**FINAL PEER REVIEW REPORT**  
**REVIEW OF CORPORATE AVERAGE FUEL ECONOMY (CAFE) MODEL AND**  
**SUPPORTING DOCUMENTATION**

**September 29, 2005**

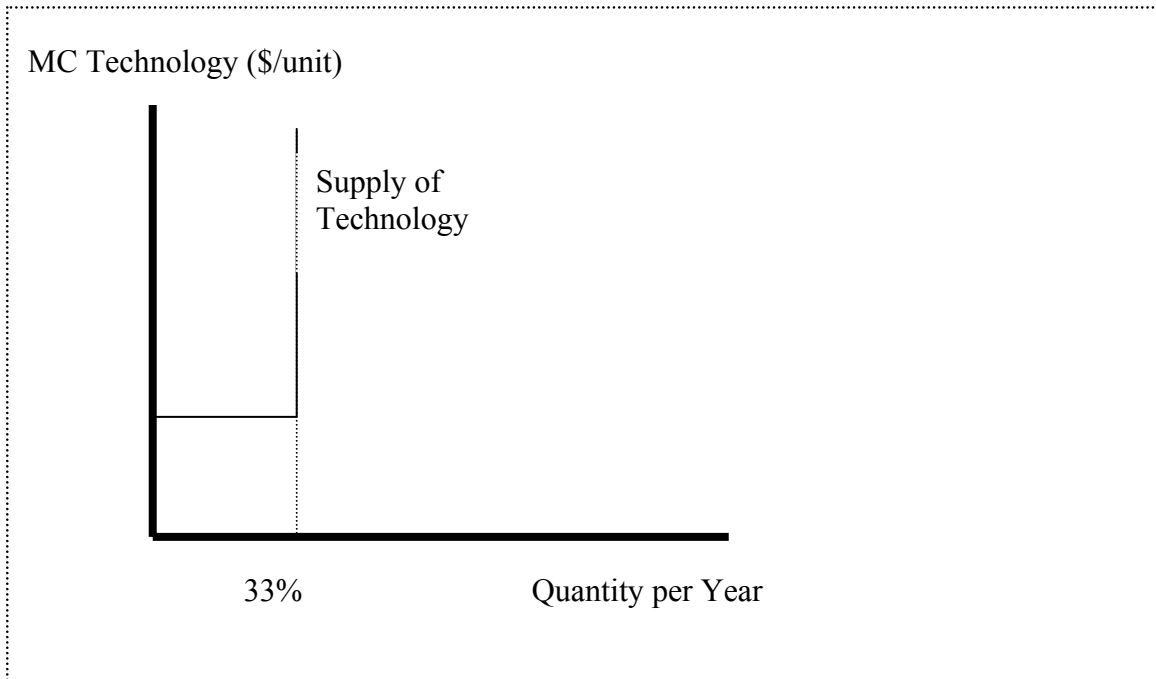
D. Figures 3 & 4. How do Figures 3 and 4 interact? Is Figure 3 nested in Figure 4 or the reverse?

G. As an alternative modeling approach to the one used here, the logical test at the top of Figure 3 could be to minimize COST<sub>eff</sub> rather than Fines Required. This would allow for a later expansion of CAFE-CEMS to allow for across manufacturer credit trading. The logical test of Fines Compliance and willingness to pay fines would come after a manufacturer applies the Best Next technology that is cost effective.

H. Figure 4. Determination of ...Applications. There appears to be a logical error in decision box: “Can pending technologies still be applied to some vehicles?” There are two paths to enter this test, but there is only one exit: “yes”, which then evaluates potential applications of pending technologies. It would seem that this decision box should have a “no” choice.

I. Figures 3 & 4. I am concerned about possibility for the non-minimization of costs and non-optimal technology choice arising from path dependency in the solution algorithm. The text (p. 19) after Figure 4 states: “Within a given technology group, the algorithm considers technologies in the order in which they appear.” It appears from Figure 3 that one could find that the most cost effective technology would be from, for example, the Accessory Load Reduction set. This would then be applied; next a technology from Transmission Modification would be best, and so on. However, it might be true, that an alternative path would yield lower costs when considered as a whole. What steps have CAFE-CEMS’s developers taken to guard against this possibility? Has the order of technologies in each technology group been arranged to prevent this? Is there a way to explore alternative paths via slight changes in technologies’ costs or applicability assumptions? Given the number of technologies (and the cheapness of computing power) a global search algorithm that examined all feasible combinations of technologies may be tractable.
